MAYBERRY FILING NO. 5

PUD Development Plan, **Site Plan**
Letter of Intent

Preliminary Plan

Key Areas

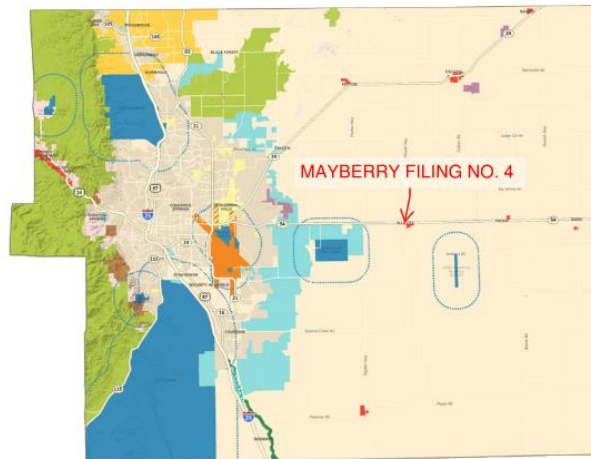
It is pretty close to the Small Town & Rural Communities Key Area, so it would be beneficial to explain how the development could impact that key area.
